CITY OF YORK
LOCAL PLAN
Site Selection Paper Addendum
September 2014

Non-Strategic Site Addendum **Page 19**

SUBMITTED SITE PLAN

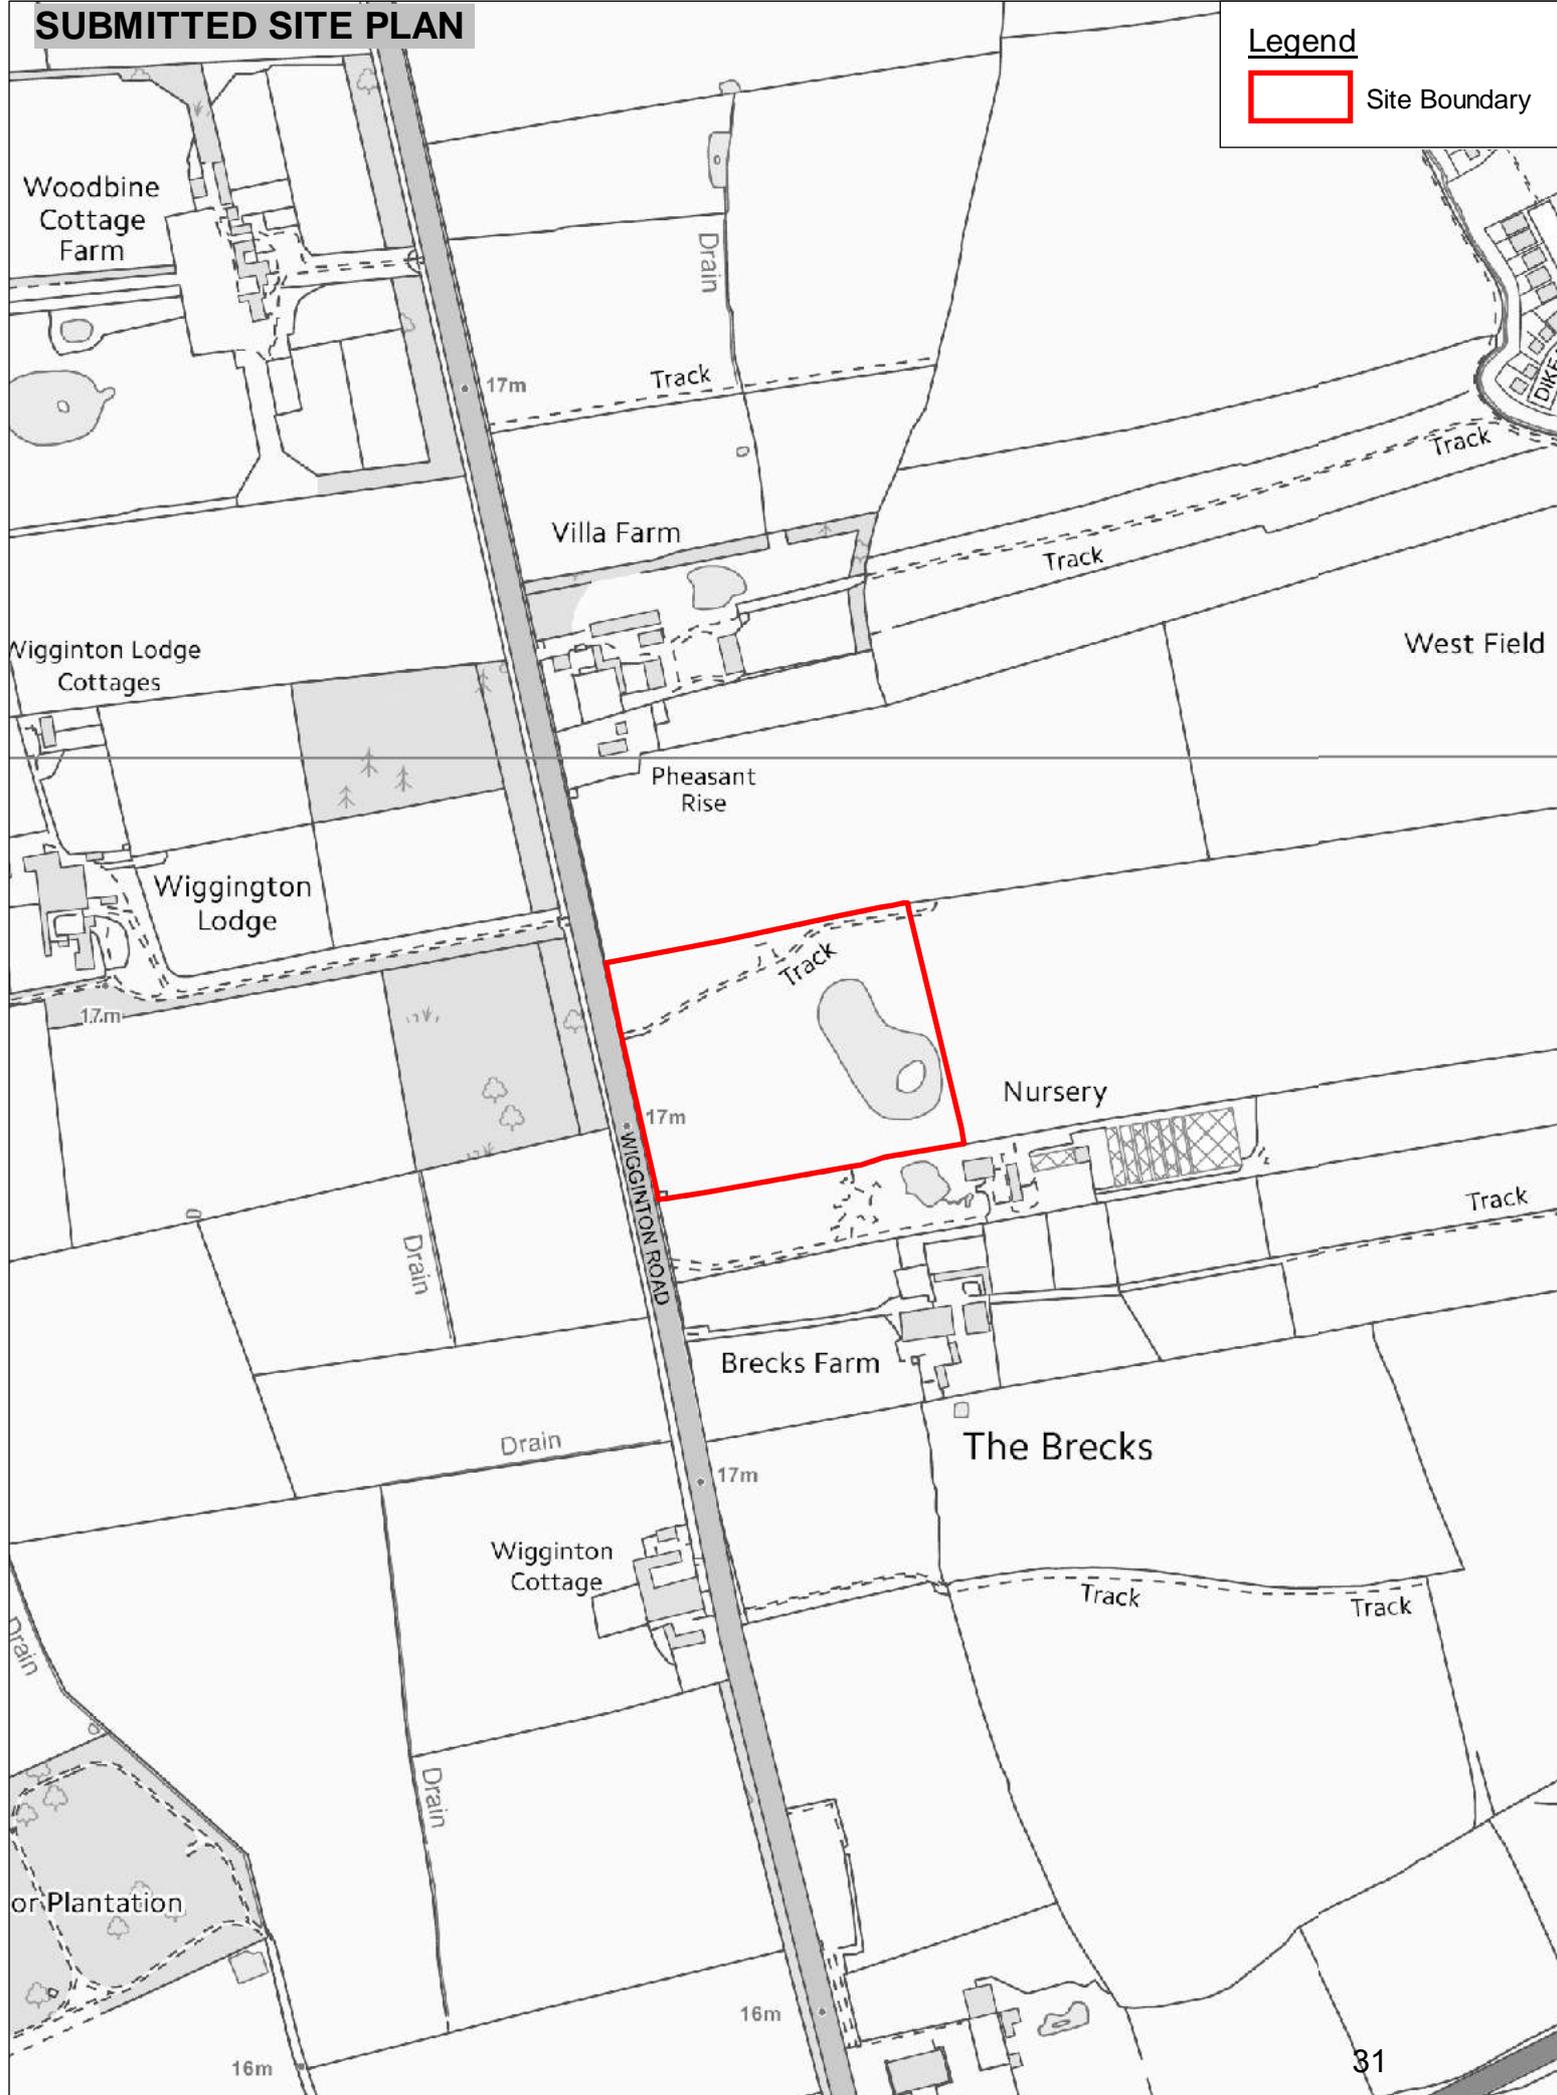
ID Ref:	ID550
New site ref:	
Original Site Ref Number:	88
Allocation Ref:	
Site Name:	Land at Villa Pond, Wiggington Road
Submitted for:	Housing/Leisure
Agent:	Peacock and Smith

Response submitted by:	Peter Wood
On behalf of:	Landowner
Additional Evidence Through FSC:	No
Summary of Response Recieved:	Object to FSC rejection of site for tourism, sport and recreation for circa 22 eco cabins. Site fails criteria 1 (HC&S - green wedge and criteria 4). Para 81 of NPPF states that 'should enhance beneficial use of the green belt incl. opportunities for outdoor sport and recreation. No further evidence submitted.
Flooding/Drainage:	This site is located in flood zone 1.
Landscape Comments:	It is considered that development of this site would compromise the green wedge designation in this location
Ecology Comments:	
Transport Comments:	
EDU comments:	
Open Space Comments:	
Archaeology Comments:	
Retail Comments:	
Proposals Map Action Required:	No action
Trajectory implications:	N/A
ID:	5
Officer Recommendation:	The site is within a green wedge designation (fails criteria 1) and also fails criteria 4 (access to services). Site is not considered suitable for allocation. Reject - no change

SUBMITTED SITE PLAN

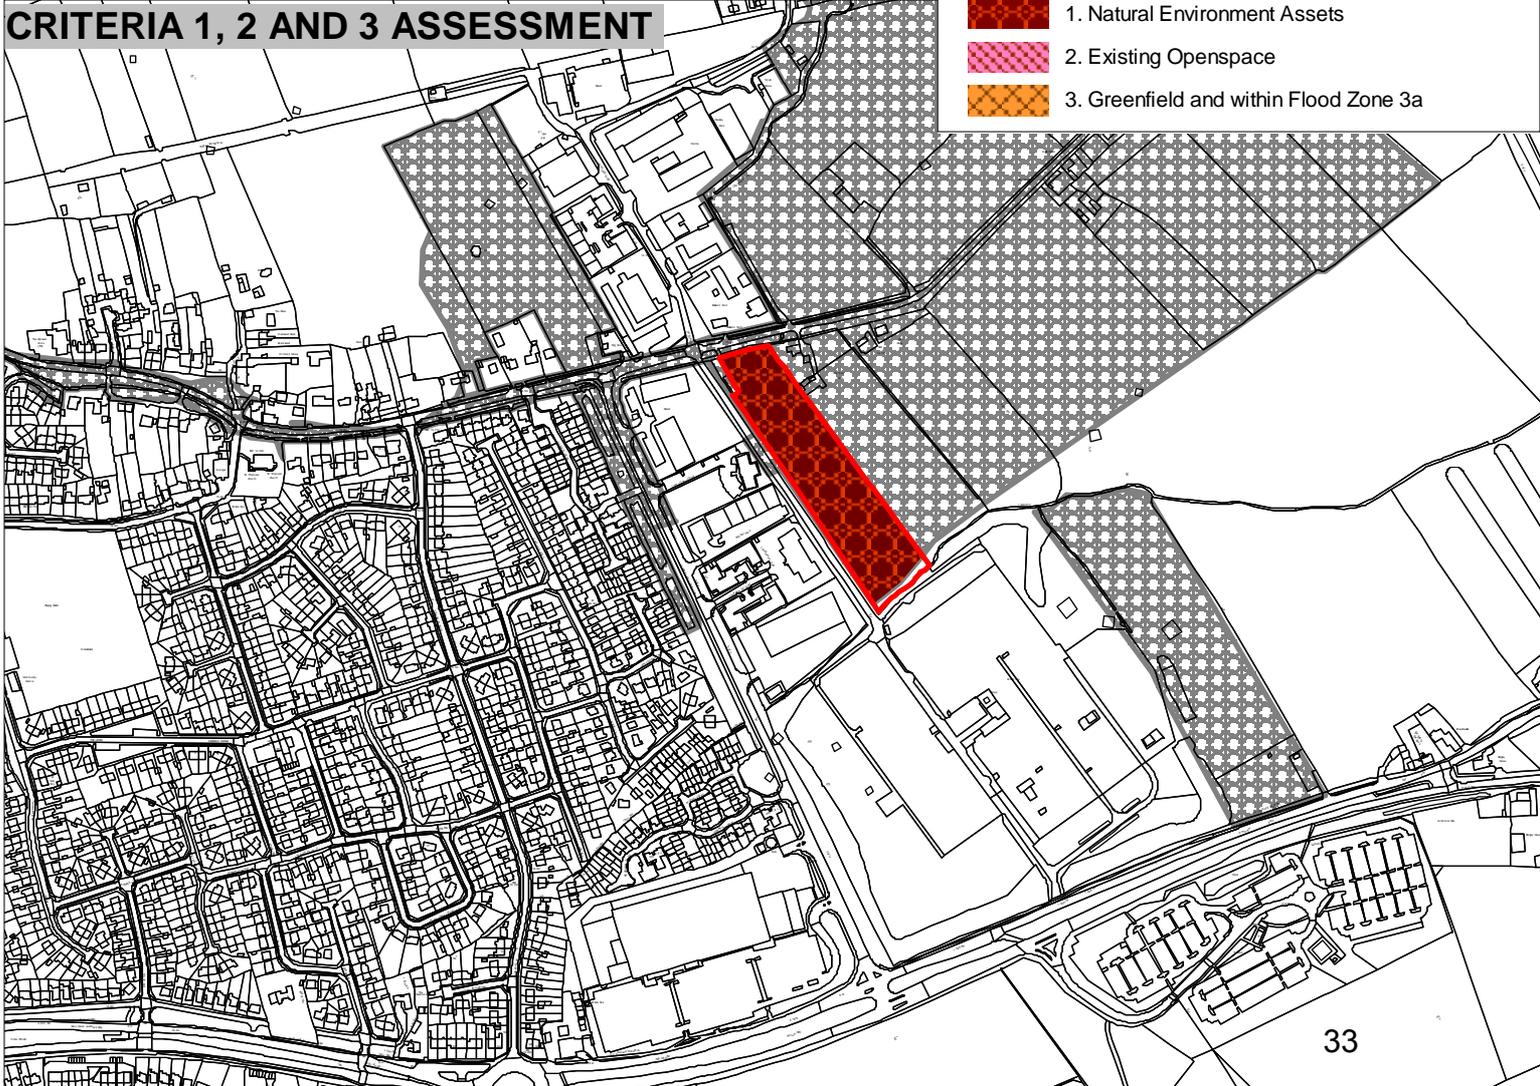
ID Ref:	ID1303
New site ref:	
Original Site Ref Number:	112
Allocation Ref:	
Site Name:	Brook Nook, Murton Way, Osbaldwick
Submitted for:	Housing
Agent:	
Response submitted by:	Landowner
On behalf of:	Landowner
Additional Evidence Through FSC:	No
Summary of Response Recieved:	Rep refers to previous site submission at Preferred Options which asks for the site to be considered for housing and employment. Also refers to renewal of planning permission (03/00230/FUL) and building regs/inspections confirming development started Jan 2008. This is for approved caravan site. Also started work on approved access road. No further evidence submitted
Flooding/Drainage:	Part of site is within flood zone 3b
Landscape Comments:	Site fails Criteria 1 of the Site Selection methodology - land is within Historic Character and Setting (Area preventing coalescence). No new evidence submitted. RED
Ecology Comments:	N/A
Transport Comments:	N/A

EDU comments:	N/A
Open Space Comments:	N/A
Archaeology Comments:	N/A
Retail Comments:	n/a
Proposals Map Action Required:	N/A
Trajectory implications:	N/A
ID:	6
Officer Recommendation:	Site fails criteria 1 of Site Selection methodology as it is within an area preventing coalescence (Historic Character and Setting). No further evidence submitted.REJECT - NO CHANGE

SUBMITTED SITE PLAN

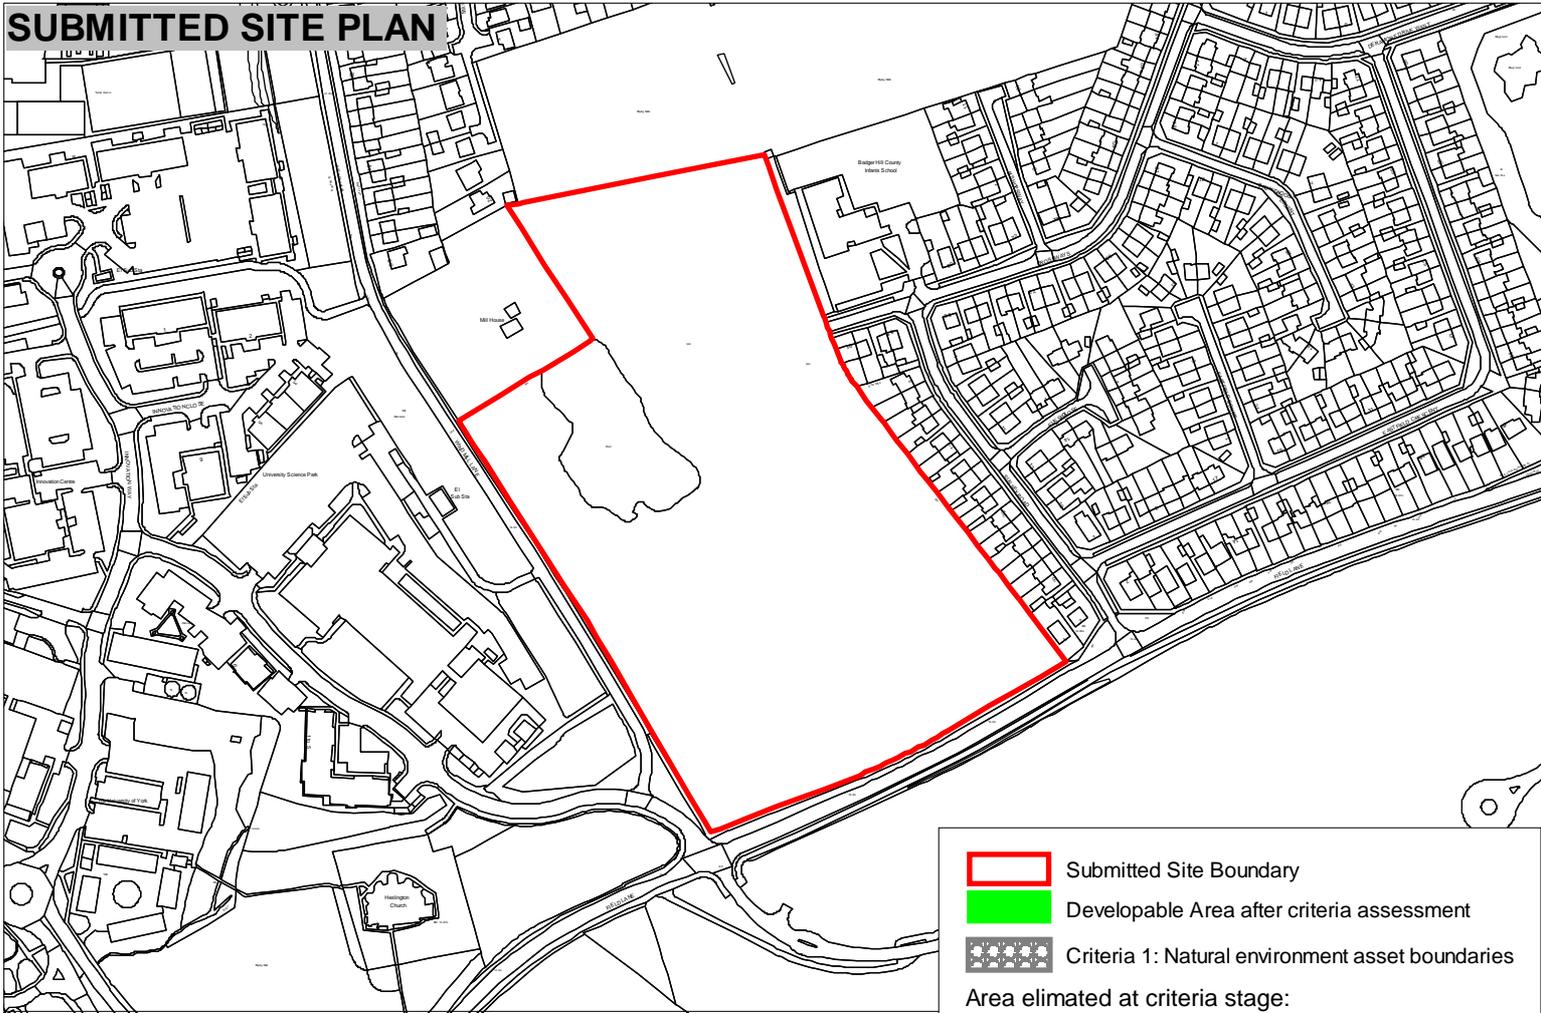
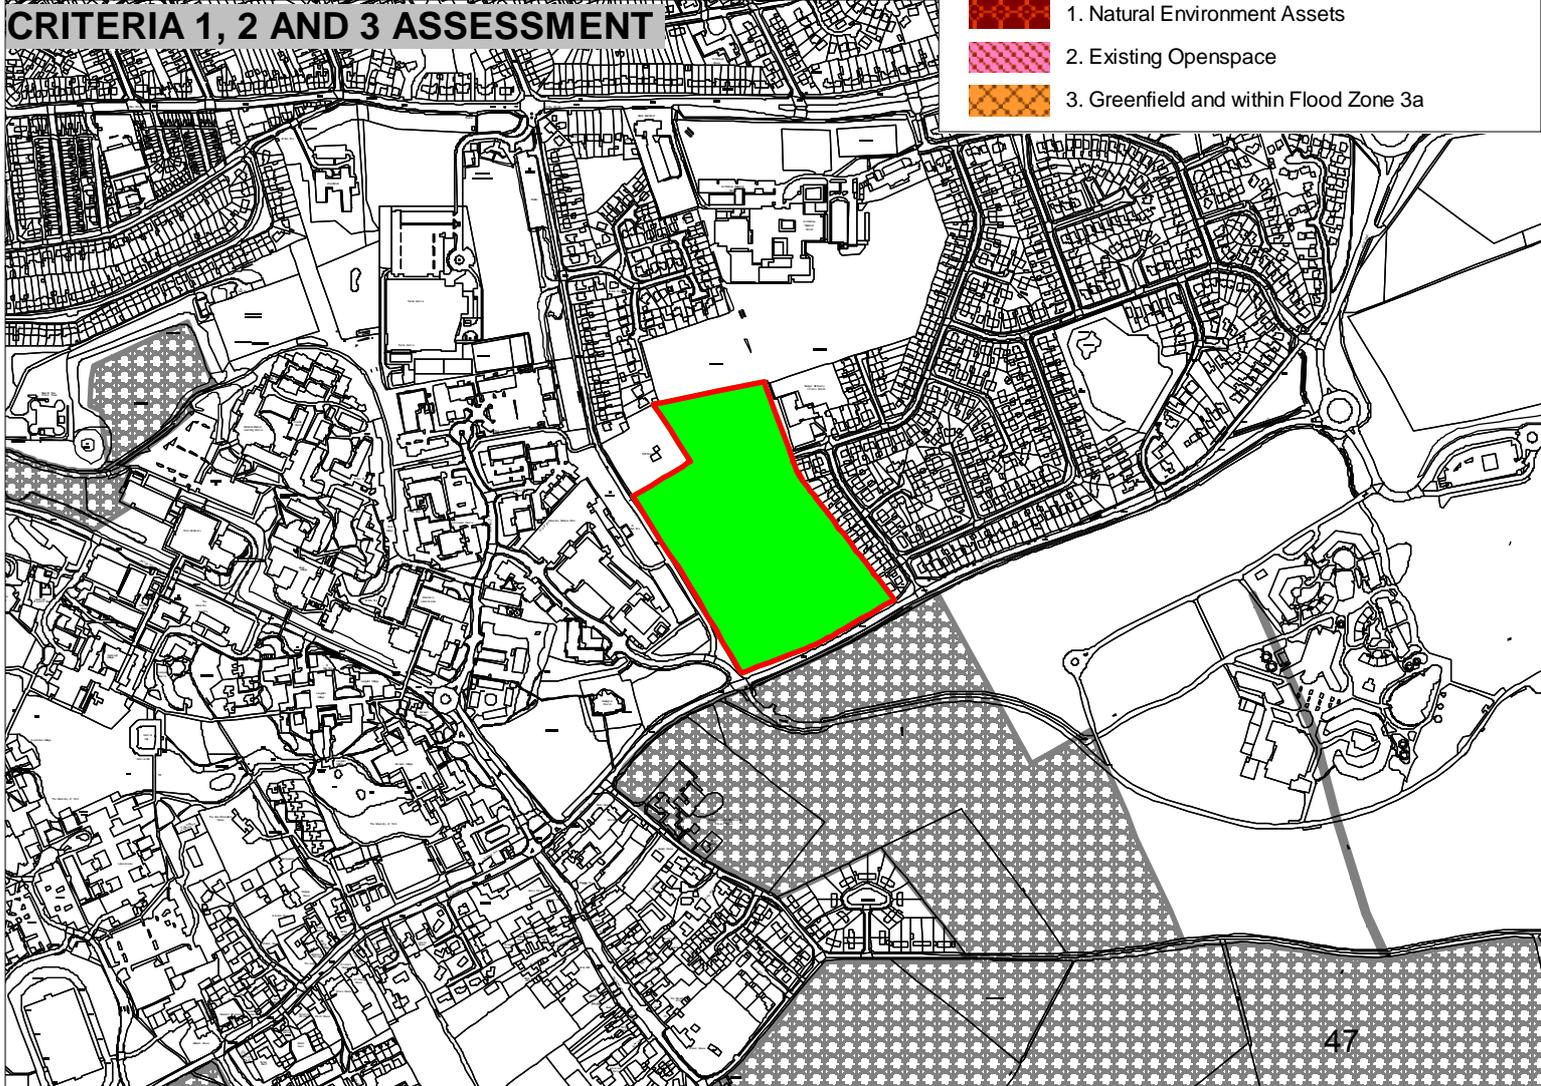
Response submitted by:	John Kirkham
On behalf of:	Persimmon Homes
Additional Evidence Through FSC:	No
Summary of Response Recieved:	Rep received which disputes the findings of the technical officer assessment in the FSC relating to impact on Character and Setting of the City - Coalescence. It is considered that the development of the Heslington East campus to the south has divorced Ponds Field from the countryside and created obvious man made bunds parallel to Field Lane and within the campus that serve to reduce further any limited views that remain of Heslington. Not reasonable to suggest that the development of Ponds Field will result in the coalescence of Badger Hill with Heslington. It will not result in development south of Field Lane because it is part of the Heslington East campus. It will not lead to development of greenspace east of the church and will not create pressure on greenspace west of the church. Propose that development will be set back from Field Lane leaving a clear vista of the church and allowing the hedgerow to stand as boundary to Field Lane

Flooding/Drainage:	No further comments in addition to FSC. GREEN
Landscape Comments:	No further Landscape Assessment submitted to substantiate comments made. It is considered this site is important for the setting of Heslington Village and provides separation from Badger Hill. Development of the site would compromise the landscape setting of Heslington and change and reduce the separation from Badger Hill.
Ecology Comments:	No further comments in addition to FSC. Great Crested Newt survey dates form 2008 so further survey required. Presence of Palmate Newt suggested in survey which are rarer in York than GCN. Site forms part of local corridor that would be significantly affected by its development. AMBER
Transport Comments:	No further comments in addition to FSC. GREEN
EDU comments:	n/a
Open Space Comments:	No additional comments to FSC. GREEN
Archaeology Comments:	No additional comments to FSC. An Archaeological desk based assessment and evaluation will be required to identify archaeological features and deposits. The understanding of the area has changed due to campus 3 evacuations. Roman coffins were discovered and therefore there is likely to be further archaeological evidence on site. Disagree with evidence submitted. AMBER

No further evidence submitted. It is considered that this site is important for the setting of Heslington village and should be retained. Development of the site would compromise the landscape setting of Heslington. It is recognised that mitigation measures have been put forward however these are not considered sufficient to prevent a change in the character and setting of the village. REJECT - NO CHANGE
